Form 3160-5 (June 2019)	UNITED STATES DEPARTMENT OF THE INTERIOR BUREAU OF LAND MANAGEMENT	FORM APPROVED OMB No. 1004-0137 Expires: October 31, 2021
SUNDRY NOTICES AND REPORTS ON WELLS <i>Do not use this form for proposals to drill or to re-enter an abandoned well. Use Form 3160-3 (APD) for such proposals.</i>		5. Lease Serial No. NMNM121490
		6. If Indian, Allottee or Tribe Name

EOG respectfully requests an amendment to our approved APD for this well to reflect the following changes:

Rattlesnake 28 Fed Com 513H (FKA 506H) API #: 30-025-51967

Revised Permit Information 02/22/2024:

Revised Wellbore

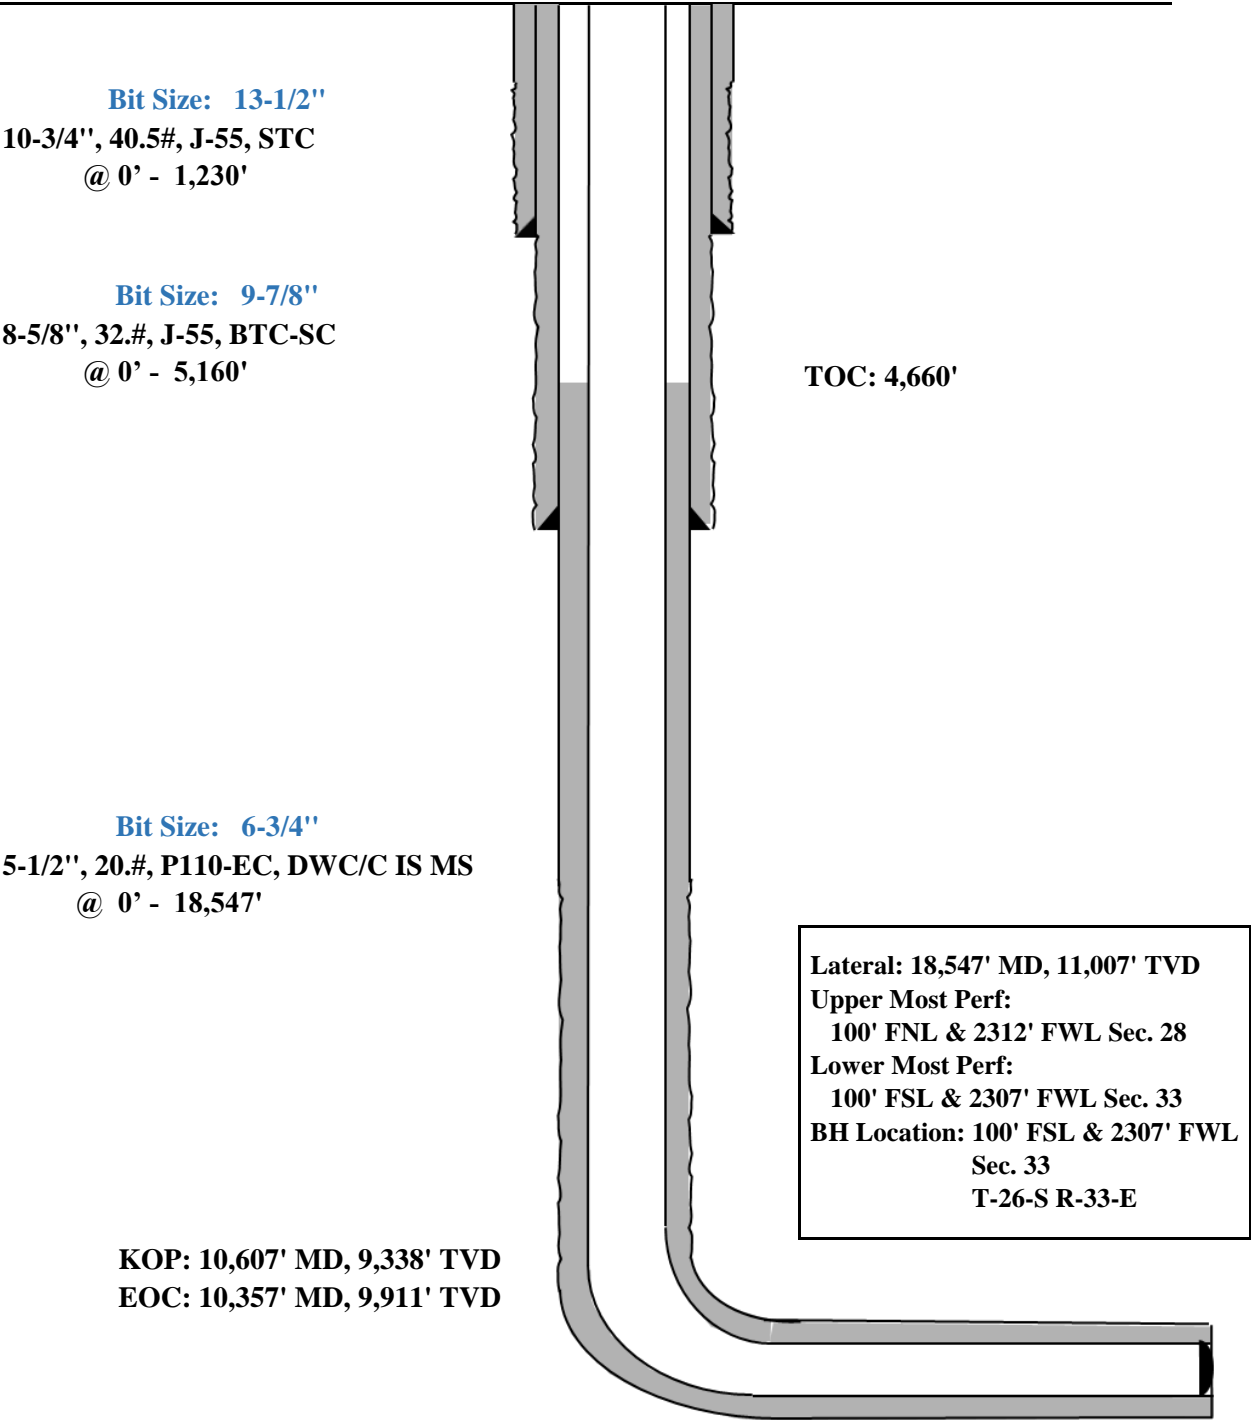
Change name from Rattlesnake 28 Fed Com 506H to Rattlesnake 28 Fed Com 513H.

Change BHL from T-26-S, R-33-E, Sec 33, 2453' FNL, 330' FWL, Lea Co., NM,
to T-26-S, R-33-E, Sec 33, 100' FSL, 2307' FWL, Lea Co., N.M.

Change target formation to Second Bone Spring Sand.
